PERMIT

SEWAGE DISPOSAL SYSTEM

HOWARD COUNTY HEALTH DEPARTMENT

SUBDIVISION _____ LOT _____ ROAD 3250 Roscommon Drive

P 48967

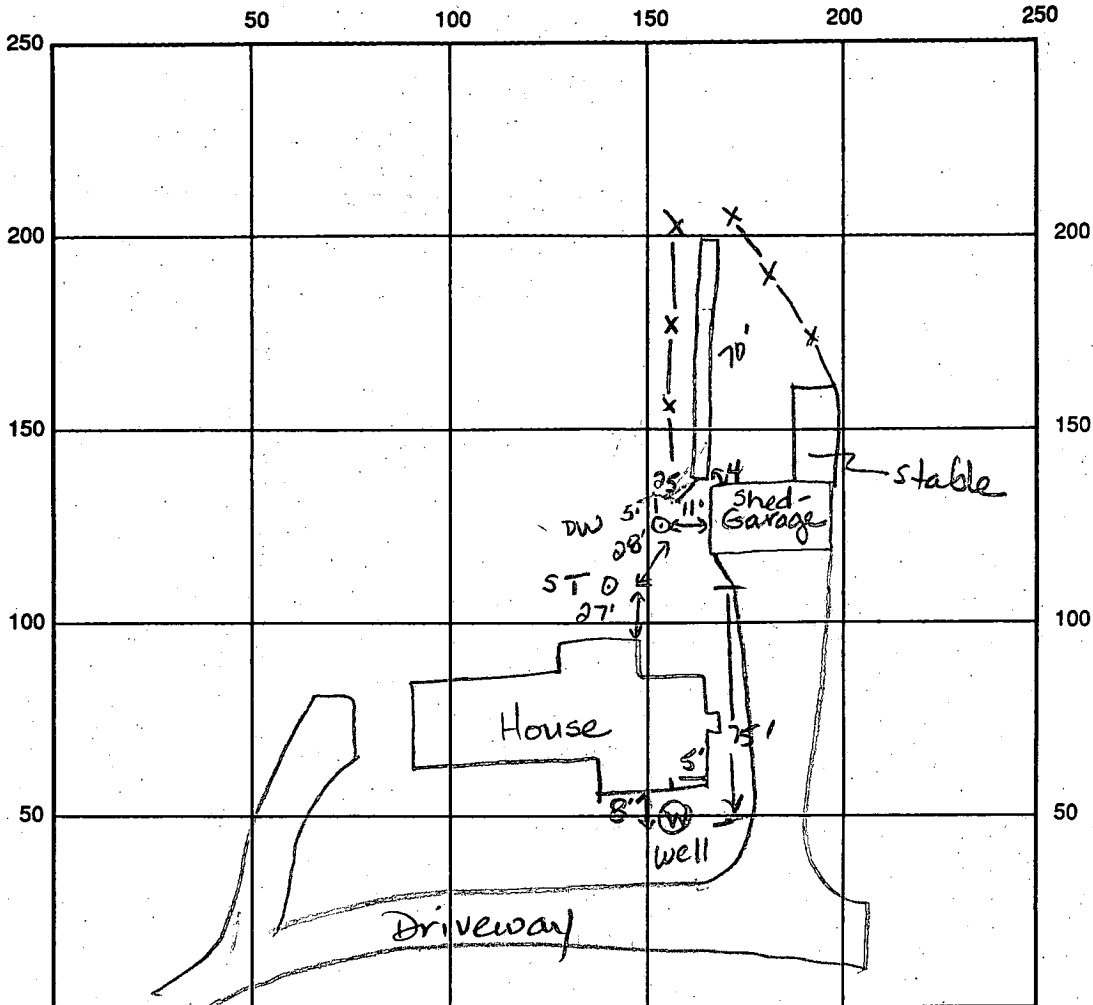
REPAIR - PURPOSE - DRYWELL HAS FAILED. - Full
Call for inspection when ground is opened so sanitarian can recommend repair. 11/16/92

11-17-92 125 sq ft bedroom with drywell, 11.0 ft bottom, 5.0 ft inlet, 65 ft trench minimum. JEN

REMARKS: 11-17-92 OK to add stone, pipe & paper. Sewer line between septic tank and drywell replaced. Old cast iron line had collapsed. PVC line was covered. JEN 11-18-92 Contractor reported length of trench to be 70 feet. All work was covered 11-17-92, JEN

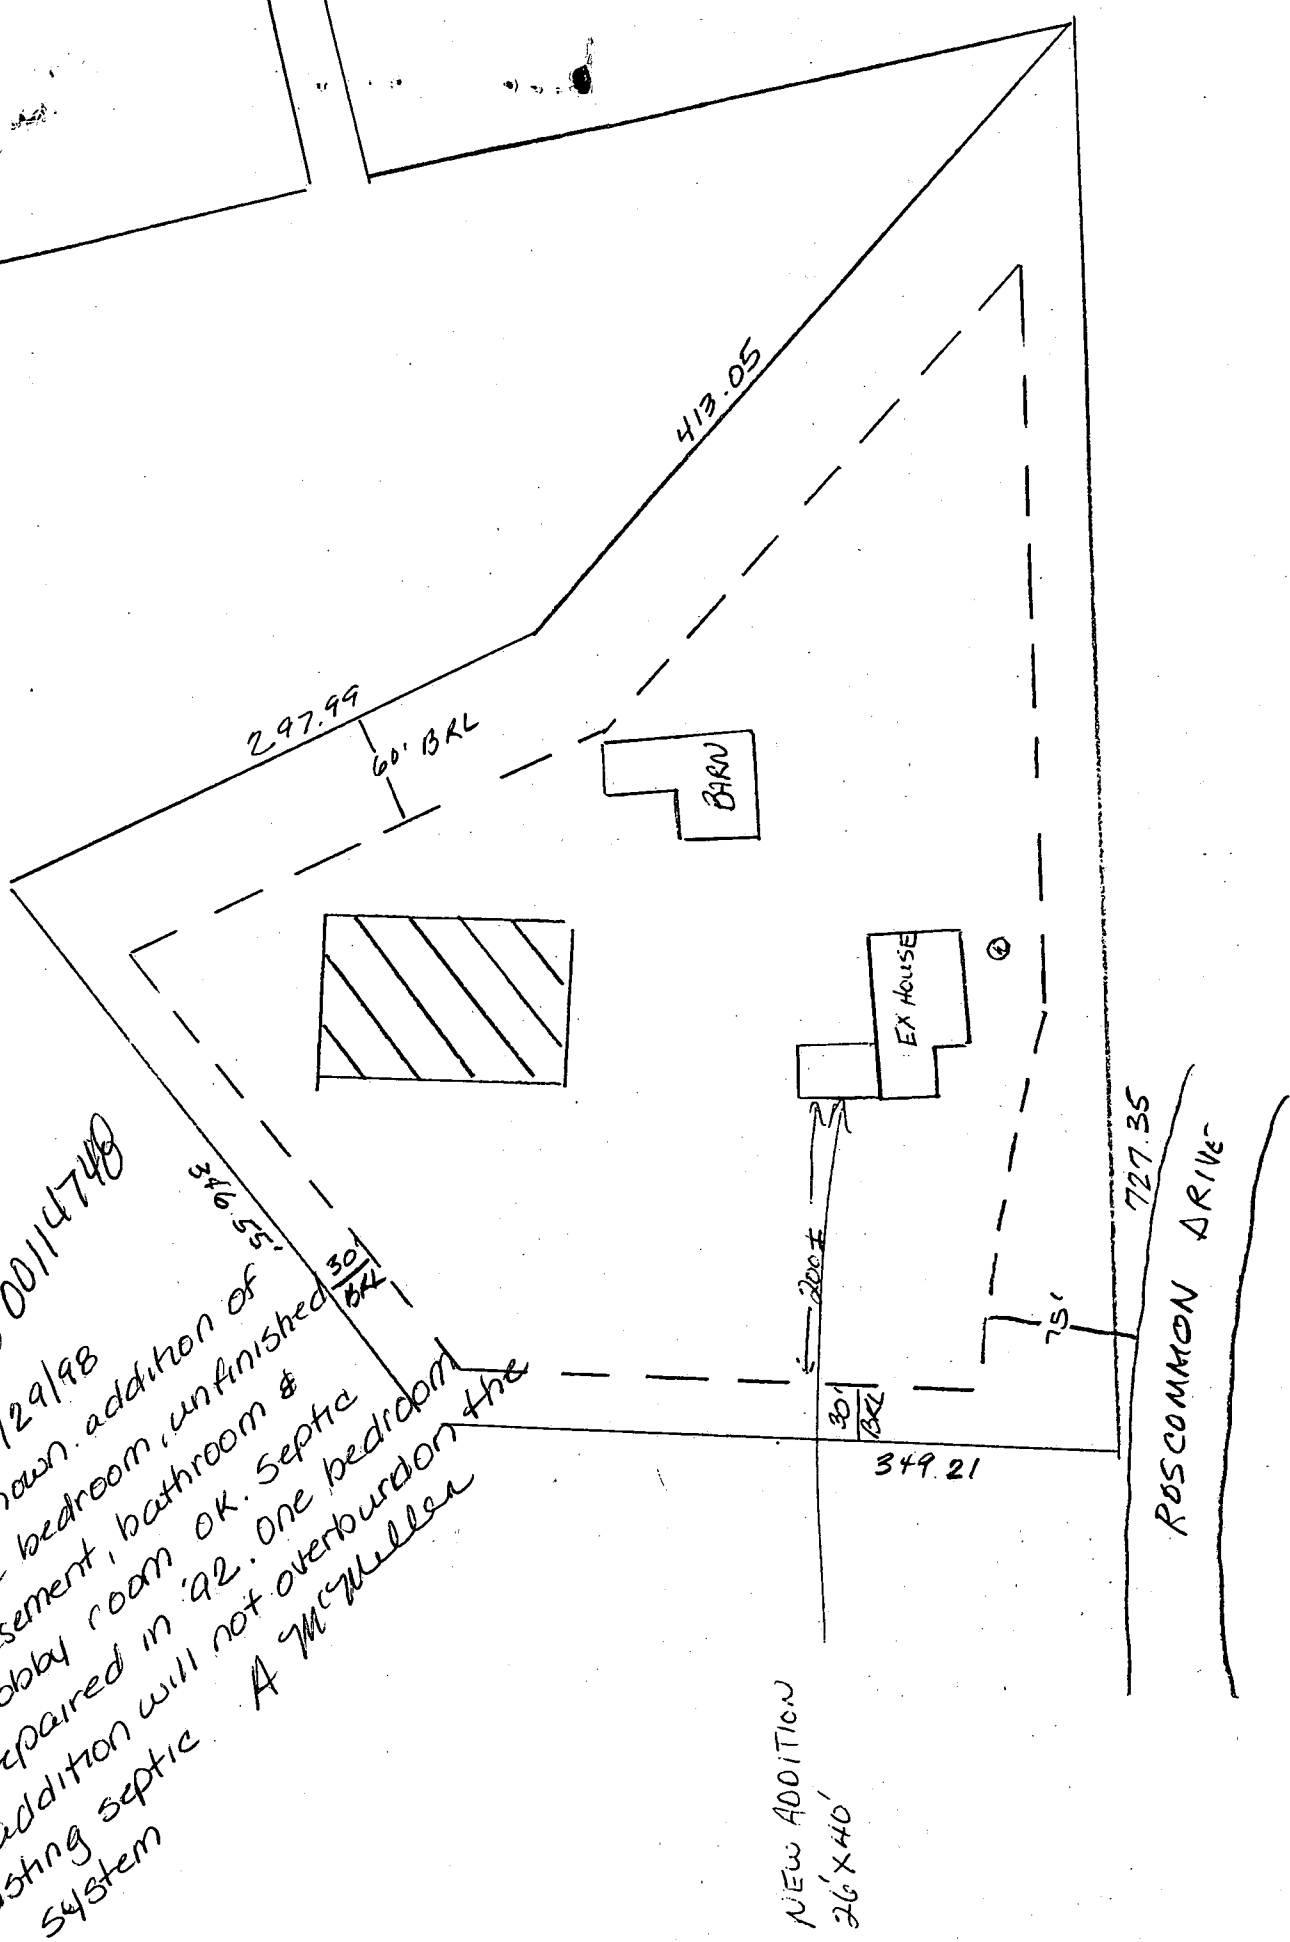
REASONS FOR REJECTION OR HOLDING 20 FEB 68 - Copy of plat required

before building permit will be released

APPROVED BY Raymond Hodges FOR Dry Well DATE 20 MARCH 68
(KIND OF SYSTEM)
